Record of Decision
Photocircuits Corporation
Operable Unit No. 1
City of Glen Cove, Nassau County, New York
Site Number 130009

March 2008

APPENDIX A

Figure 3 - RI Groundwater Sampling

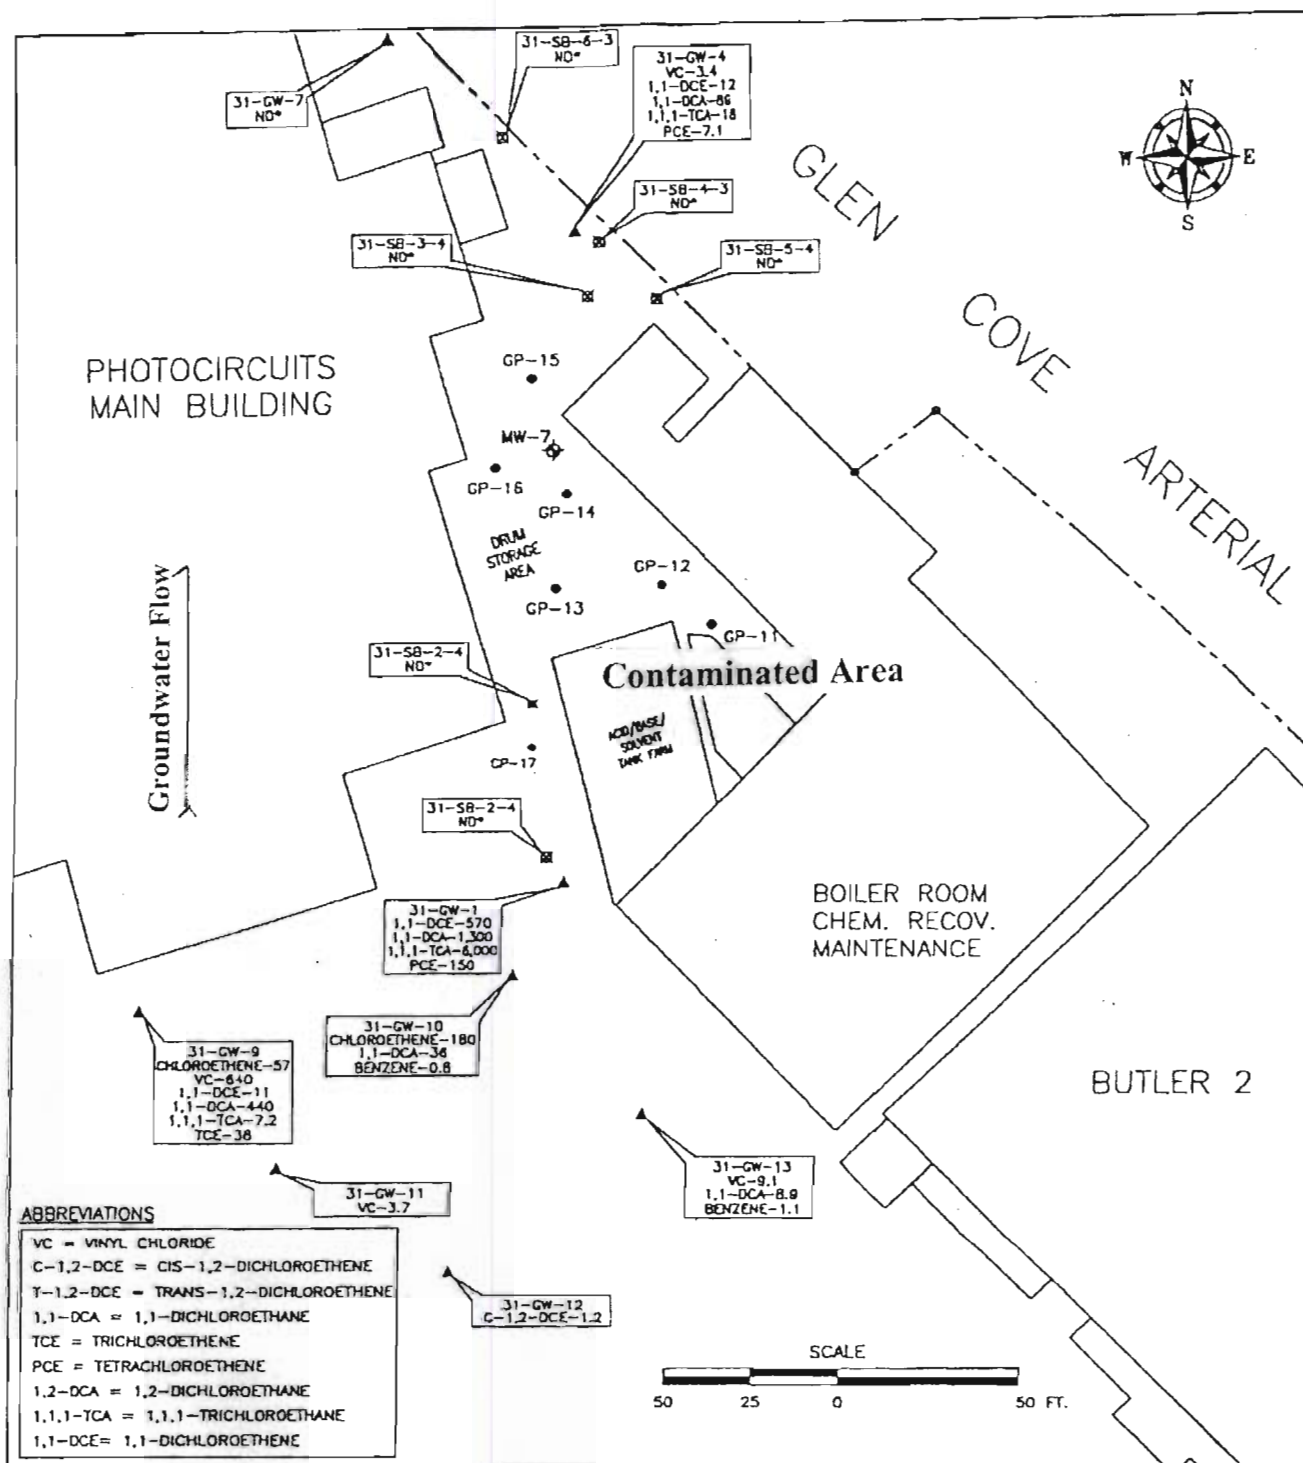
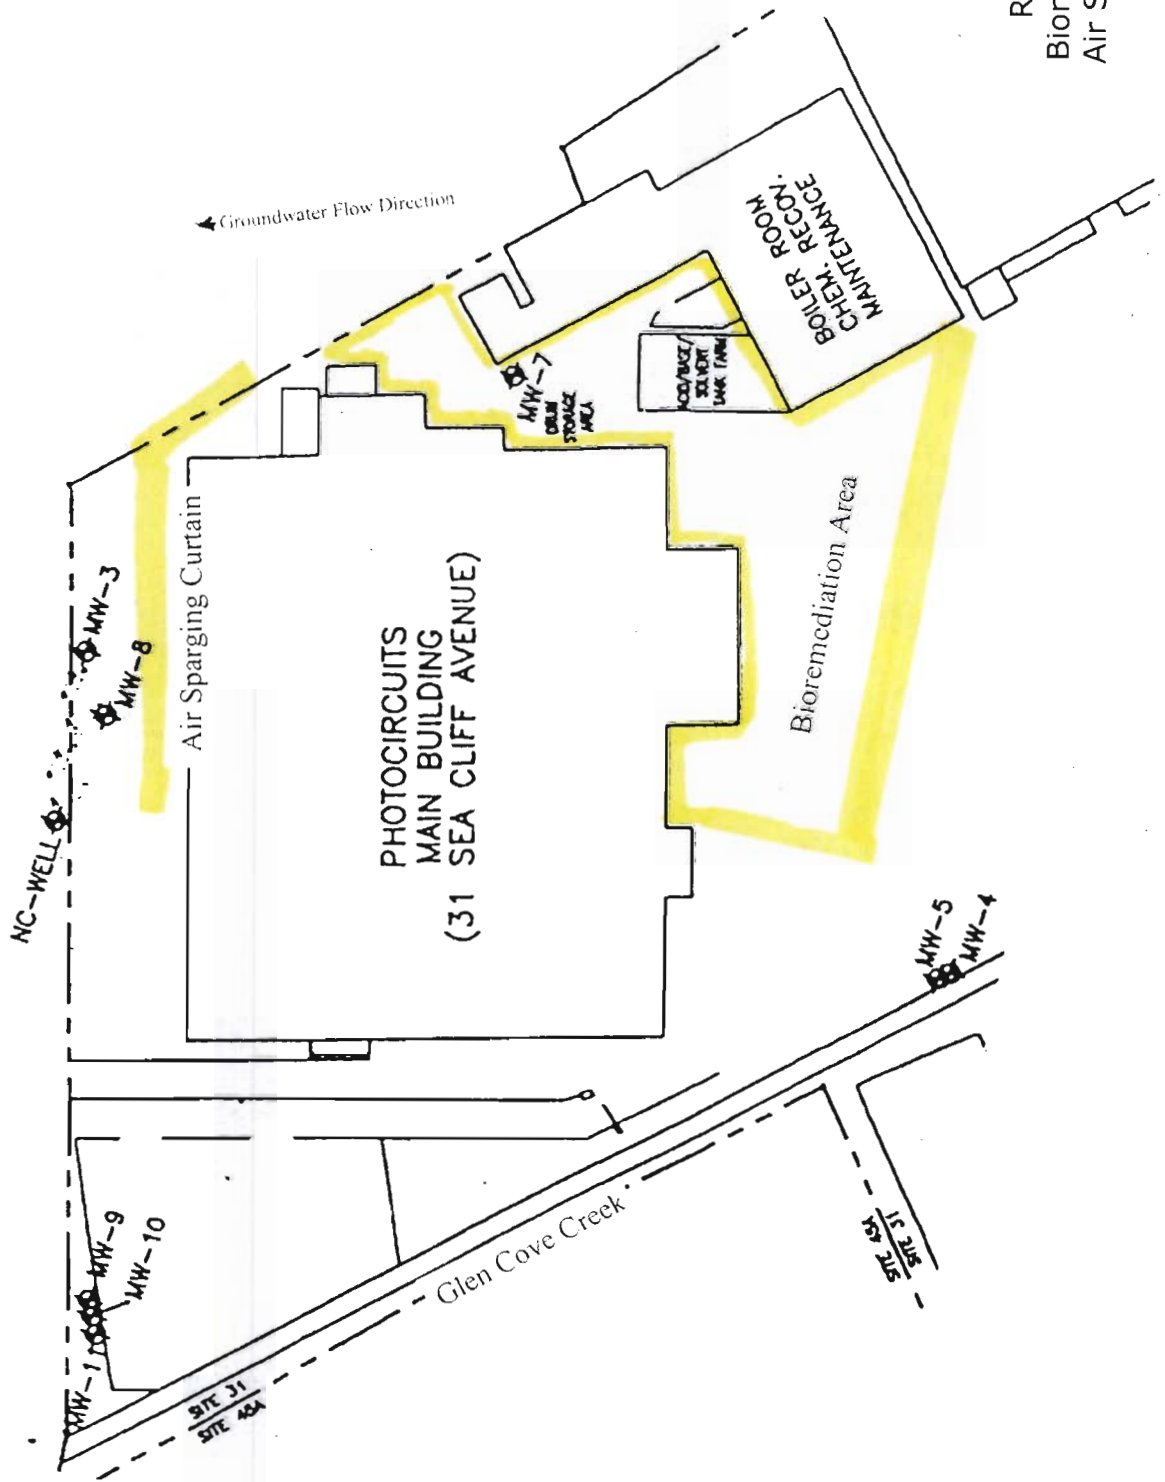
COMMENT 34: Comment 5: P. 4, Para 2, Line 2: A comparison of Figures 2 and 3 indicate that much of the Photocircuits property, including the entire area near Butler 2 was never investigated. This would result from the fact that only a Focused Remedial Investigation was performed. The NYSDEC should include data for other areas of the site, if any exist. If no additional data exist, additional investigation - including sampling within the building footprint underlying

RESPONSE 34: Investigations performed prior to the FRI include the "Source Area Investigation for the Sea Cliff Industrial Area" performed in 1992, and the "Preliminary Site Investigation" performed in 1996, both cited in the PRAP. These reports identified the drum storage and tank farm areas located to the east of the Photocircuits' main building as the primary areas of concern at the site. Inclusion of the data from these investigations is beyond the scope of a PRAP, however, both documents are available in the repositories.
